Replies to comments on Mechanical GA of CW Pump house (Rev 01)

PROJECT	YADADRI THERMAL POWER STATION (5X800 MW)		
OWNER	TELENGANA STATE POWER GENERATION CORPORATION LIMITED		
OWNER'S CONSULTANT	TATA CONSULTING ENGINEERS LIMITED BANGALORE		
EPC CONTRACTOR	BHARAT HEAVY ELECTRICALS LIMITED, NEW DELHI UNIT : BOILER AUXILIARIES PLANT ; RANIPET PACKAGE : DM PLANT		
TITLE	EQUIPMENT LAYOUT OF DM PLANT		
DRAWN	BB SAHU	Sd/-	29.12.18
CHECKED	G RANENDRAN	Sd/-	29.12.18
APPROVED	M RAMAKRISHNA	Sd/-	29.12.18
ALL DIMENSIONS ARE IN MILLIMETRES	SHEL DRAWING NO.		
	1-WT-500-01296

TELANGANA POWER GENERATION CORPORATION LIMITED 5x800 MW YADADRI THERMAL POWER STATION Comments on BHEL Drawings / Document							
Drawing/Document Title: GA Drawing for Combined Fuel Oil Pump House (Unloading through road tanker cum Pressurising & Heating P/H)							
Comments on drawing/Document No.:PE-DG-417-166-A003 REV.02							
SL.NO.	TSGENCO/TCE Comment vide Transmittal no.: TCE.11005A-ME-VDT-375 dated 24.01.2020	BHEL REPLY	TSGENCO/TCE Comment vide Transmittal no.: 11005A-ME-VDT-435 dated 09.07.2020	BHEL REPLY	TSGENCO/TCE Comment vide Transmittal no.: TCE.11005A-ME-VDT-442 dt.23.07.2020	BHEL REPLY	Remarks
1	Indicate th

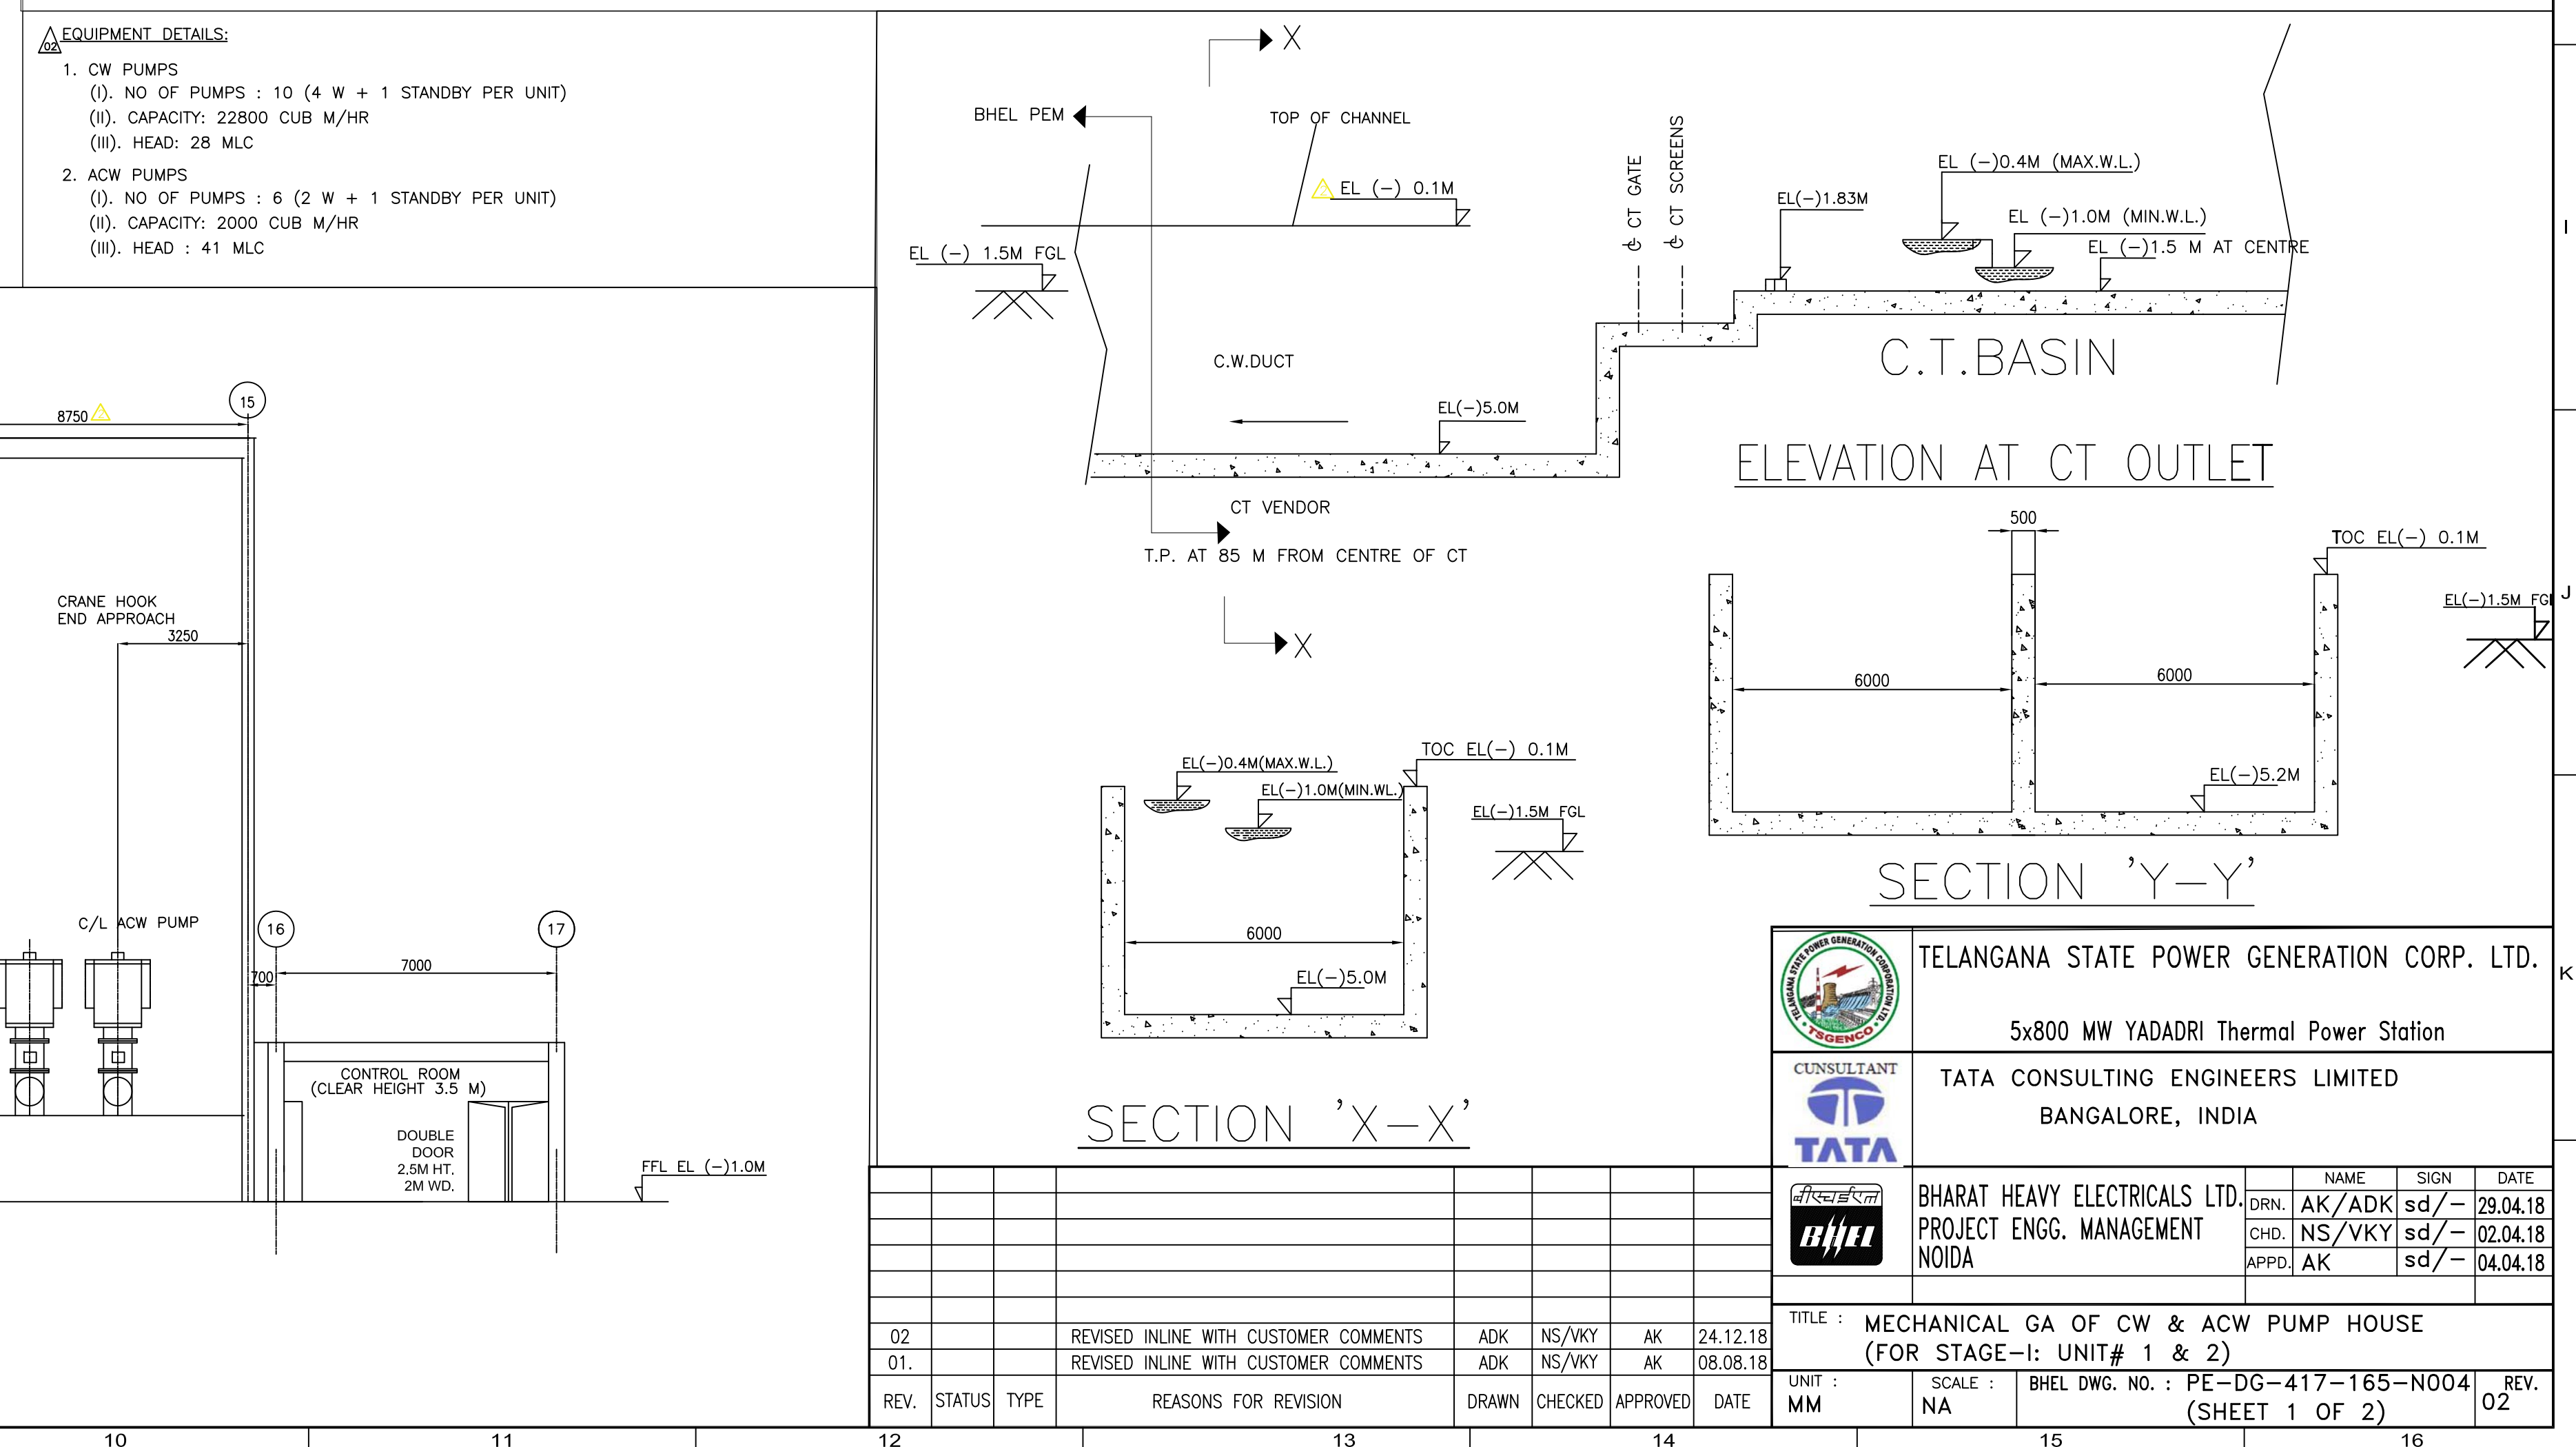
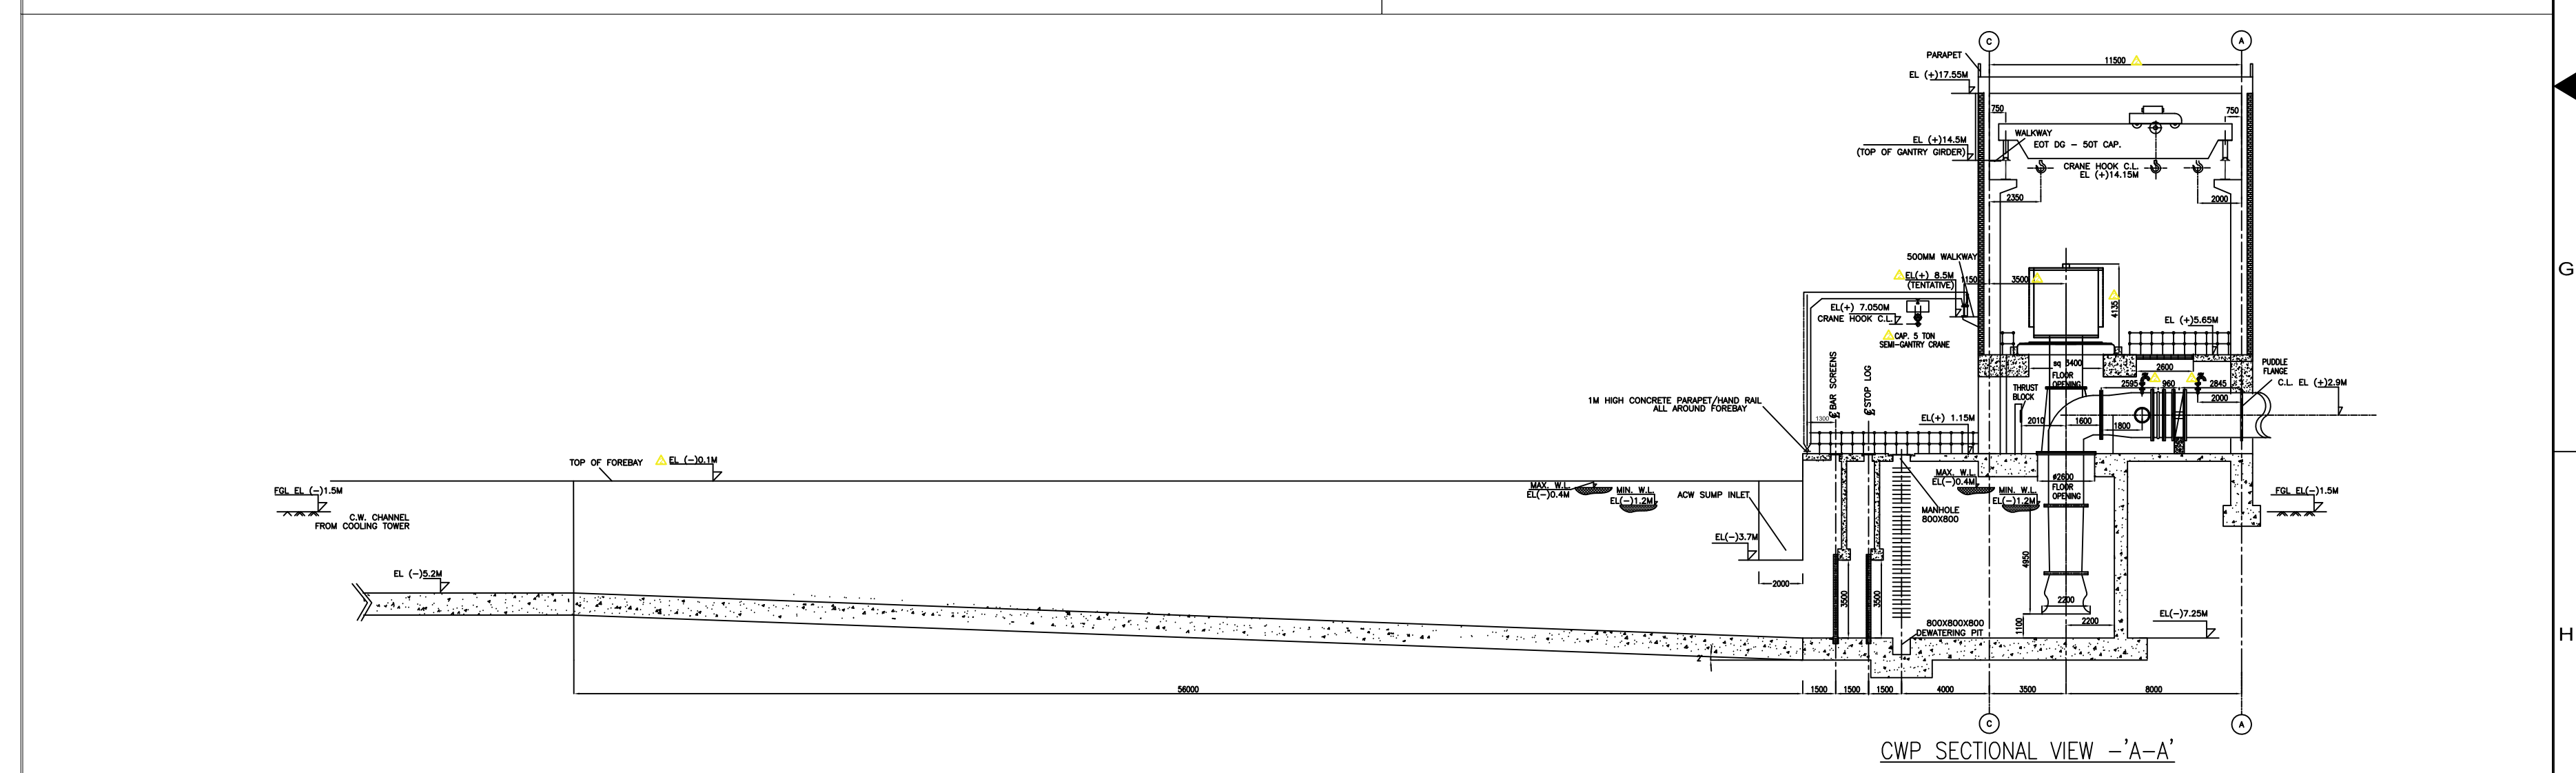
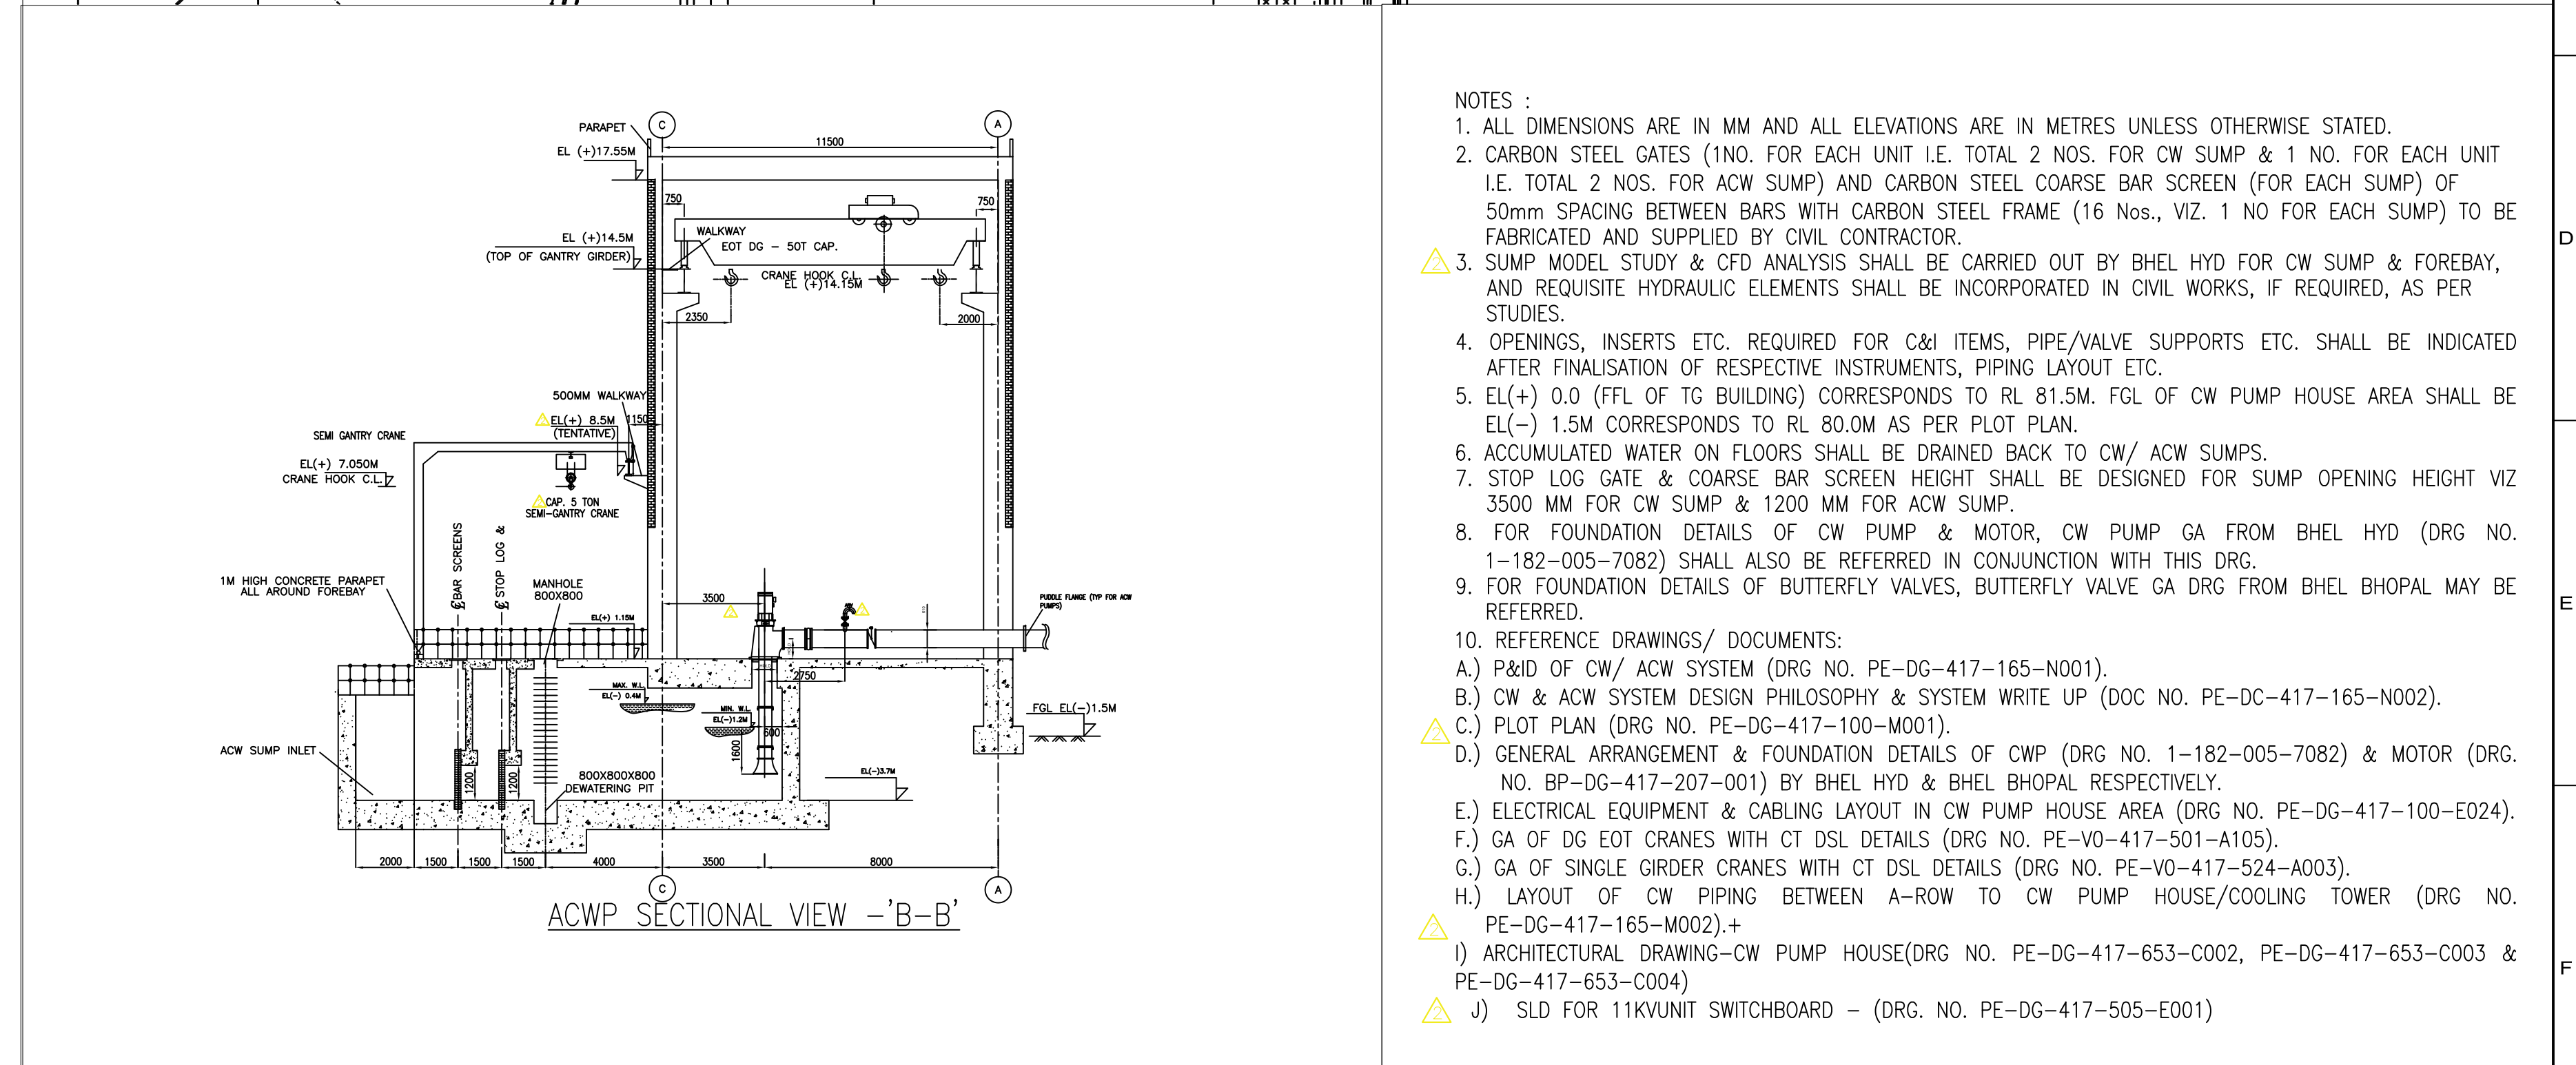
S. No	Customer Comments	BHEL Replies dated 24.12.2018
Comments marked on Word file		
1	Is there any storage rack considered for storing the stop logs.	Please note a Paved area near maintenance bay (500 mm above FGL) is provided for storage of stop log gate and stools are provided in this are for resting of stop log gate. There is no storage rack envisaged.
2	Indicate dimesion	Noted & incorporated.
3	Indicate the cross travell approach	Already provided in "CWP sectional View A-A"
4	56785?	checked & corrected.
5	3 No's LT shall be provided as per P & Id.	Noted & incorporated.
6	Provision shall be provided for Chlorine dosing along with other CW chemical dosing system.	Noted & Incorporated.
7	Please mark the dimension.	Noted & incorporated.
8	BHEL to explain where this kind of arrangement is made in earlier projects (except KTPS). BHEL to provide the reference for those projects (especially NTPC projects).	This arrangmenet is as per BHEL standard practice and already provided in number of projects viz. 2X660 MW RRUYNL Suratgarh TPS, 1X500 MW DVC Bokaro 'A' TPS, 1X700 MW KPCL Bellary TPS Unit-3 etc.. Further sump model study along wth CFD analysis shall be conducted for establishing the correctness of layout.

9	Does the arrangement is inline with HIS requirements?	
10	BHEL to confirm whether flow study & Modeling has been done to arrive the layout. If done and arrived the arrangement. BHEL to submit the same for reference	
11	Indicate electrical MCC roon	Please note there is no swichgear room in CWPH. Please refer PE-DG-417-505-A001.
12	FFL shall be marked.	Noted & incorporated.
13	CW pump and ACW pump foundation details shall be shown.	CW pump & ACW pump foundation details shall be provided in Civil GA of CW pump house.
14	BHEL to ensure the proper approach to the pumps	Noted.
15	Weight of Pump and motor shall be provided.	Weight of CW pump & motor shall be indicated in respective GA drawing (FP-1-182-005-7082 & BP-DG-417-207-001) submitted separately by BHEL-Hyderabad & Bhopal respectively.
16	Static load and dynamic load due to pump and motor set shall be furnished.	Static load and dynamic load due to pump and motor set shall be indicated in respective GA drawing (FP-1-182-005-7082 & BP-DG-417-207-001) submitted separately by BHEL-Hyderabad & Bhopal.

17	Pump data indicating the pump capacity, head, quantity shall be provided.	Noted & incorporated.
18	Indicate ventilation system requirement like fan and louver details shall be shown.	Ventilation system requirement shall be indicated in Architectural drawing of CW pump house (Drg no. PE-DG-417-653-C002, PE-DG-417-653-C003 & PE-DG-417-653-C004)
19	BHEL to indicate the holds as most of the equipments are to be order and are dependent on Vendor information. BHEL to indicate the same.	Noted.
21	Please mark water levels.	Water levels are already marked in CWP sectional view A-A. Further there is negligible pressure drop of 50 mm across screen and same can not be distinguished in water levels near screen in GA drawing.
22	Please indicate minimum submergence value.	Please note minimum water level in CW pump house is selected based on minimum submergence requirement and submergence requirement of 4950 mm is already indicated in the "CWP Sectional view A-A".

23	Dimension shall be provided.	Noted & incorporated.
24	Check the column grid locations and revise the dimension.	Noted & incorporated.
25	BHEL to indicate maintenance platform for motor	Maintenance platform for motor is envisaged in maintenance bay at EL (-) 1.0 M. However for local monitoring/inspection of motor, motor floor is already indicated at EL (+)5.65 M.
26	ARV shall be shown.	Noted & incorporated.
27	Dimension shall be provided.- CW Pump	Complete dimensions of CW pump shall be provided in CW pump GA drawing (drg no. FP-1-182-005-7082).
28	Please provide basis of crane selection (typical).	Required capacity of semi gantry crane is arrived as 5T, considering 10 % margin over heaviest equipment to be lifted i.e. stop log gate. Stop log gate is in two parts and weight of one part is approx. (1.8 ton+1 ton) including accessories of handling arrangement of gate. Thus selected capacity of semi gantry crane is in order.

29	EL shall be marked.	Noted & incorporated
30	Please mark the dimension.	Noted & incorporated
31	ARV shall be shown.	Noted & incorporated
